Alternative road load determination
- delta vehicle friction method -

September, 2016
JAPAN

WLTP TYPE I TEST IMPROVEMENTS AND PROPOSALS ROAD LOAD DETERMINATION, INCLUSION OF JAPANESE PROPOSAL IN CALCULATION SCHEME 1/2

GTR text Proposal (1/3)

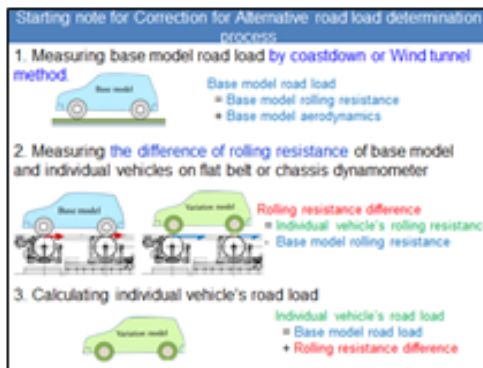
Current situation	Proposal
<p>Saving testing effort while at the same time increasing transparency Japan proposed the determination of a road load delta within the drivetrain, which was welcomed by the IWG. But this is currently not covered in the calculation formulas.</p>	<p>Clarify the description within the interpolation calculation to allow for a direct calculation of CO₂-values.</p> <p style="text-align: center;">These changes are explained on the following slide.</p>

The result or the scheme of the formula is not changed. The change should just clarify definitions in order to avoid misunderstandings and errors.

- Within a vehicle model, there might be two options for brakes: One standard one, and one sport brake, which will increase friction.
- Currently this would result in a separate road load family and two complete additional road load determinations.
- but practically the difference is e.g. 3N, which can be easily determined via a delta measurement on the one hand, and easily interpolated on the other hand.
